AMENDMENT UNDER 37 CFR § 1.111
Serial No. 09/992,410

AMENDMENTS TO THE DRAWINGS

Proposed drawing amendments are submitted with respect to Figure 2 of the drawings, along with replacement formal drawings incorporating these amendments.

Figure 2

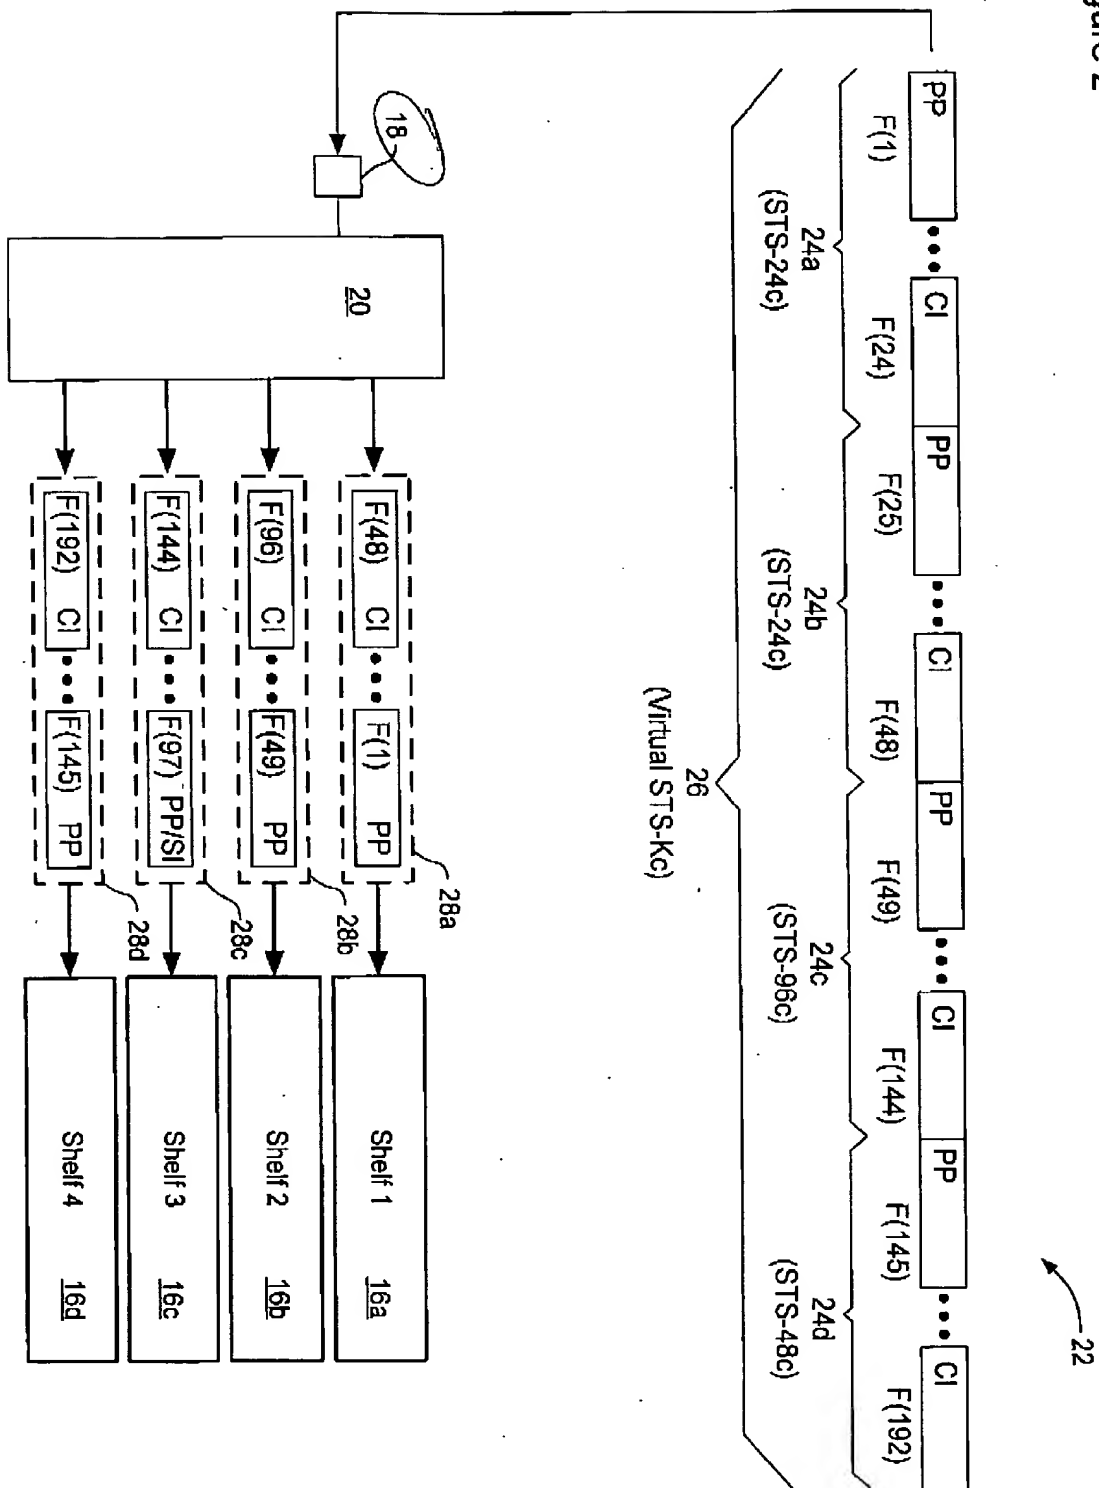
By way of the above-noted amendments, independent claims 1 and 17 have been amended to emphasize that each shelf of the cross-connect comprises a respective independent pointer processing state machine, and further to define that at least one of the sub-streams is modified "to emulate a conventional Synchronous Transport System (STS) concatenation with sufficient accuracy to enable successful pointer processing through a shelf". Claim 3 has been cancelled to avoid redundancy in view of amended claim 1. Claims 4 and 5 have been amended to reflect the revisions in claim 1. Claims 10, 18 and 23 have been amended to correct typographical errors identified therein. Pages 7 and 20 of the specification, and the abstract have been amended to correct typographical errors identified therein. Finally, FIG. 2 of the drawings has been amended to correct a reference numeral.

- the abstract and specification have been objected to in view of typographical errors identified therein;
- FIG. 2 of the drawings has been objected to;
- claims 10, 18 and 23 have been objected to because of typographical errors identified therein;
